TO: All Prospective Proposers
HSF I – Replace Emergency Generator Enclosures
IFB # 17-333 ML

RE: NAME OF PROJECT: HSF I – Replace Emergency Generator Enclosures
UMB PROJECT NUMBER: 17-333 ML

The following amends the above referenced solicitation documents and is issued as Addendum #1 dated 5/8/18. The due date and time for the **Bid Price** has been amended to **Tuesday, May 22, 2018 at or before 2:00 p.m.** Receipt of this addendum is to be acknowledged by completing the enclosed “Acknowledgement of Receipt of Addenda” form and including it with your bid price.

ROOF TO DUNNAGE
EQUIPMENT SUPPORT

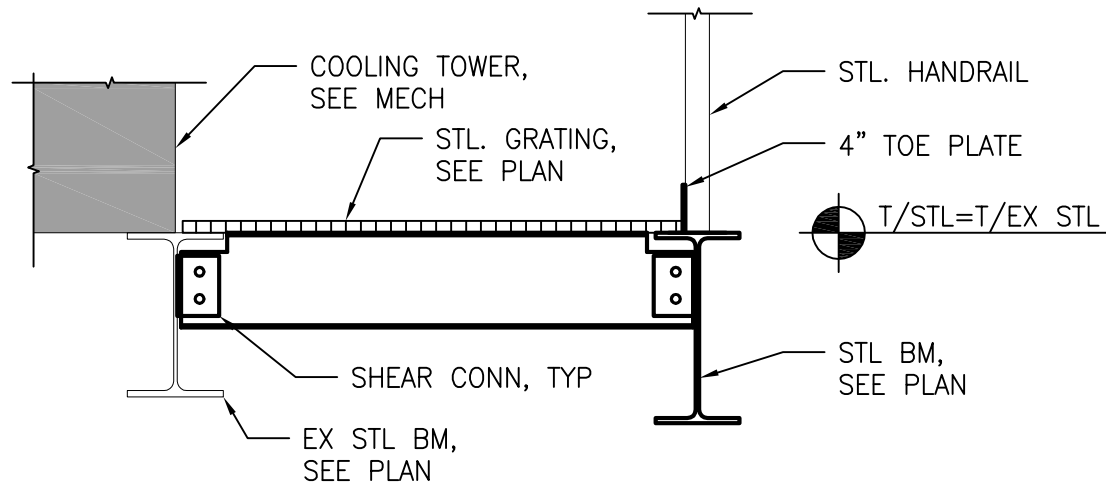
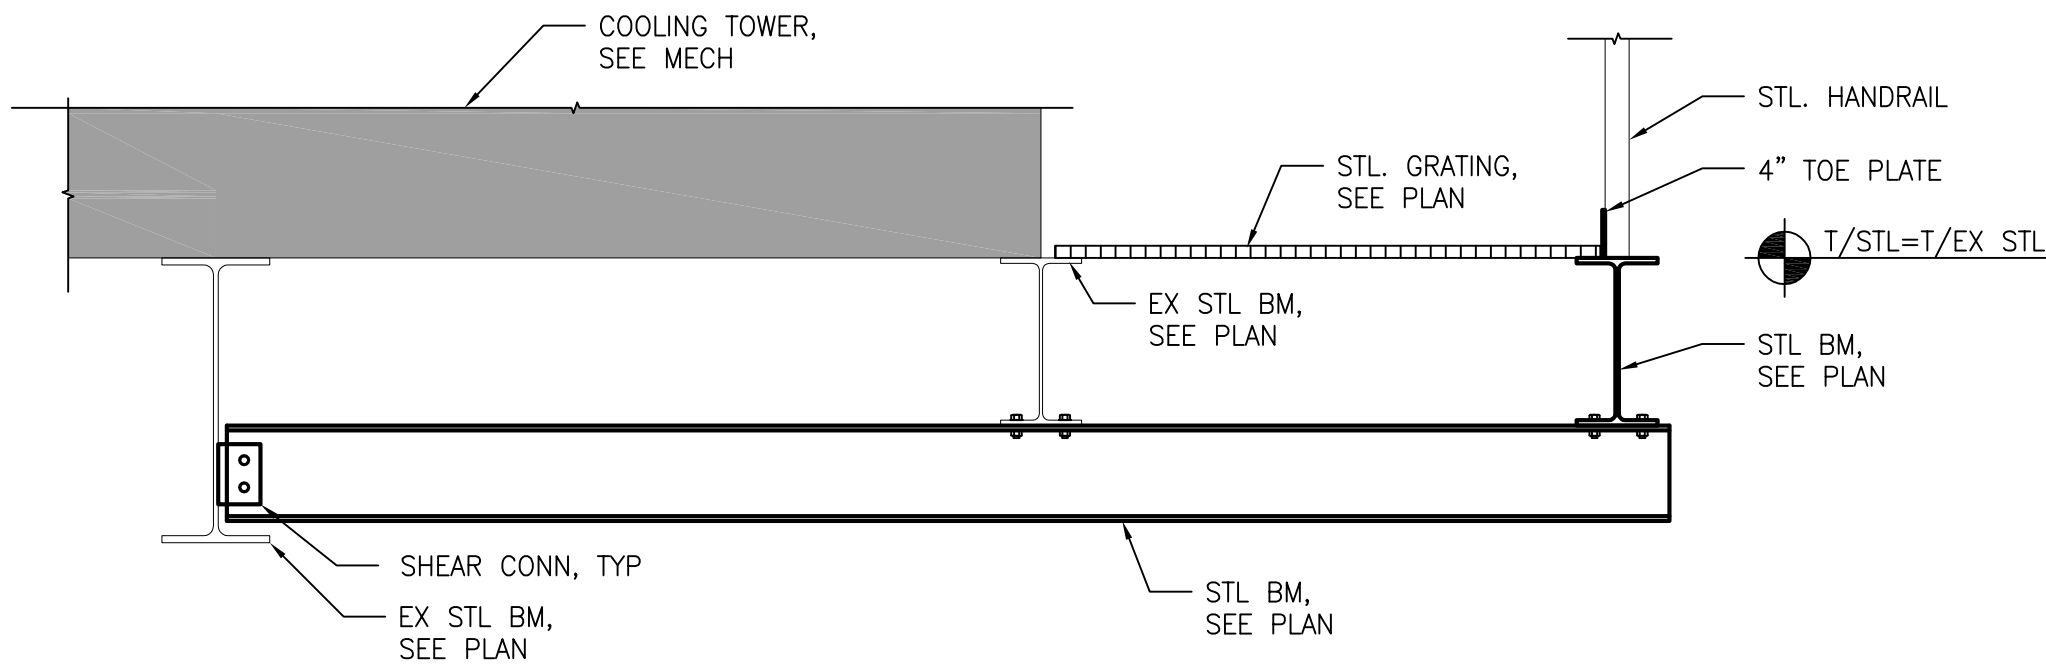
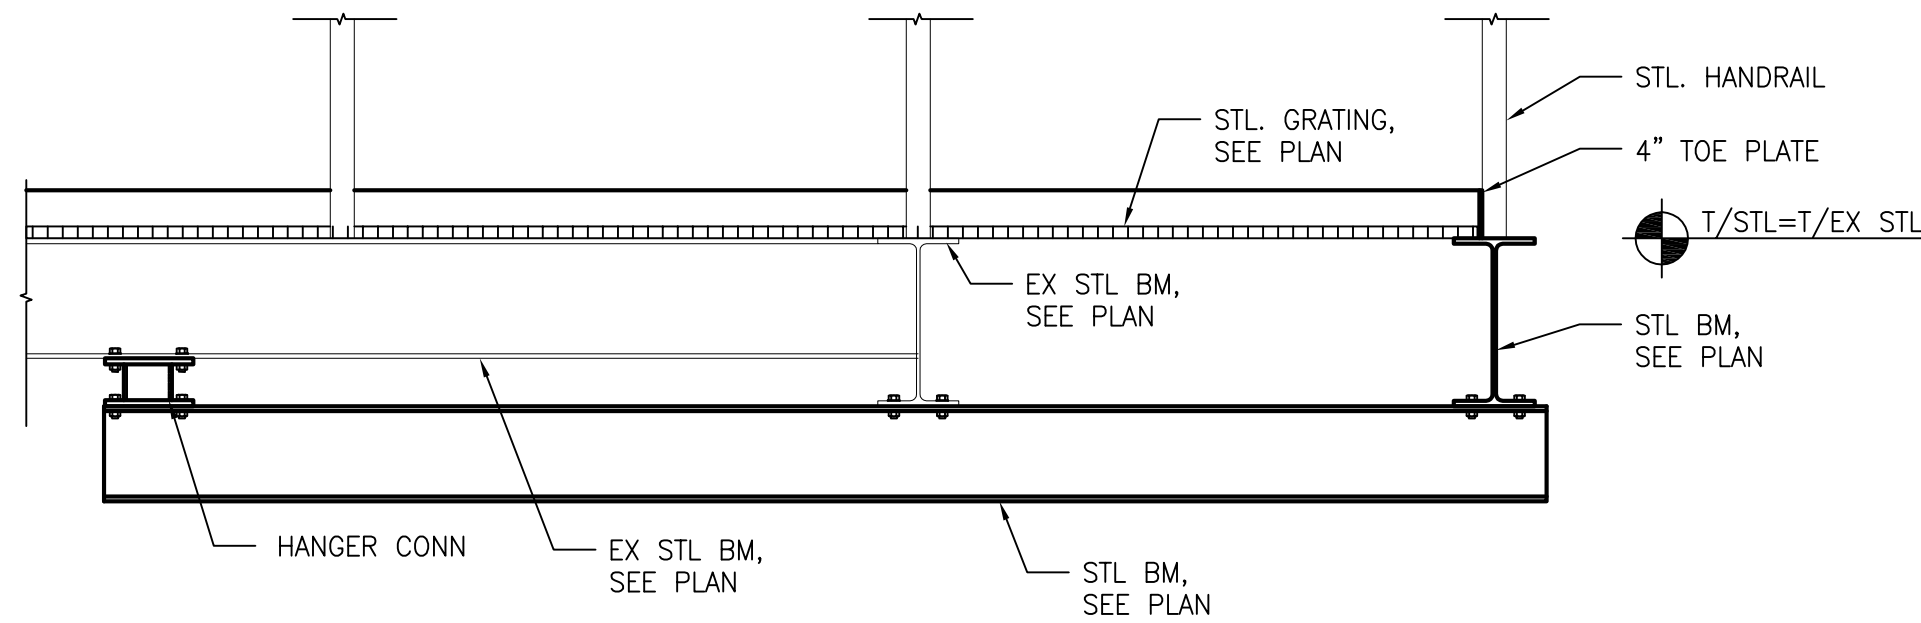
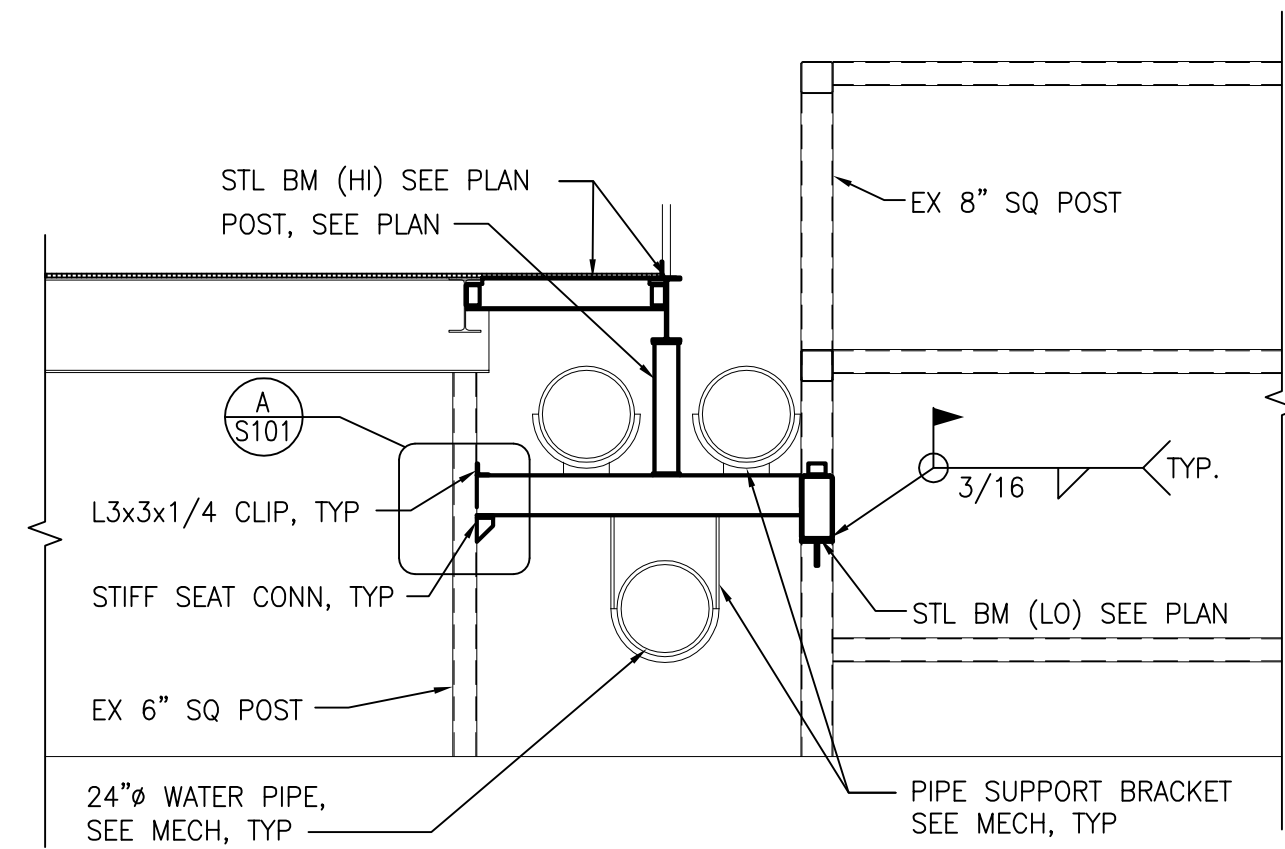
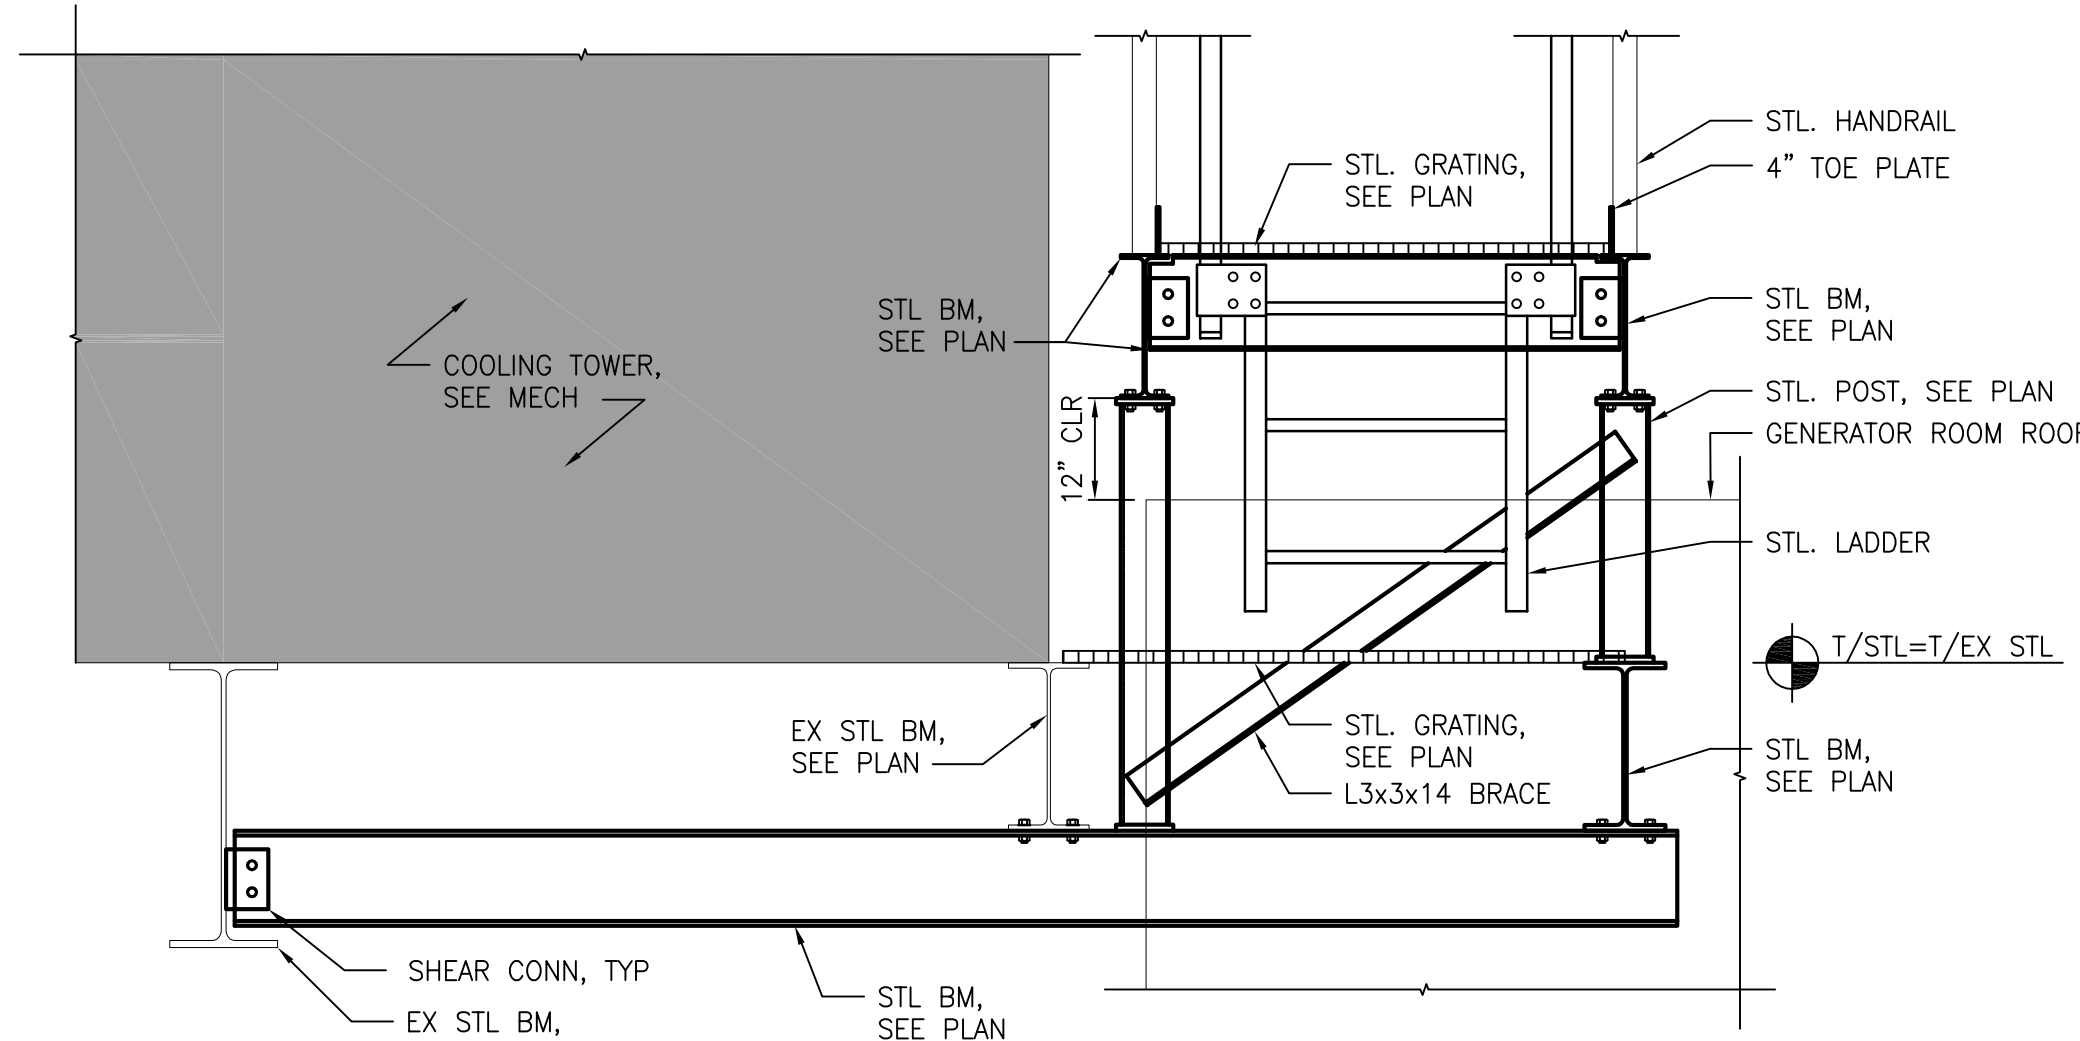
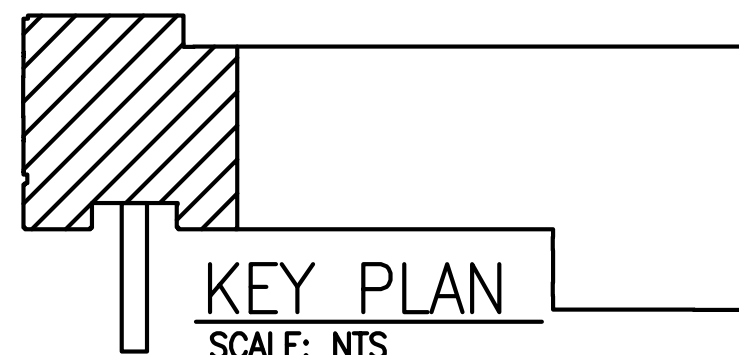
- C. Add: B. Scope of Work – 6. The contractor will be provided with an area on the roof for storage of tools, equipment and new housing components.
- D. Add: B. Scope of Work – 7. Steel walkways are currently being installed on the roof above and adjacent to the existing generator enclosures for the cooling towers. The steel dunnage will be bolted in place by the time this project is awarded. It is the intention of this project scope, for the awarded contractor, to unbolt the dunnage above and adjacent to the generators and move it to the roof deck while their work is taking place; this includes the grating. With this dunnage removed, the existing generator housing can be lifted from above and set in place. The dunnage and grating shall be reinstalled once work on each generator is complete. See the drawing attached to Addendum #1 for a detail of the dunnage location and specification.
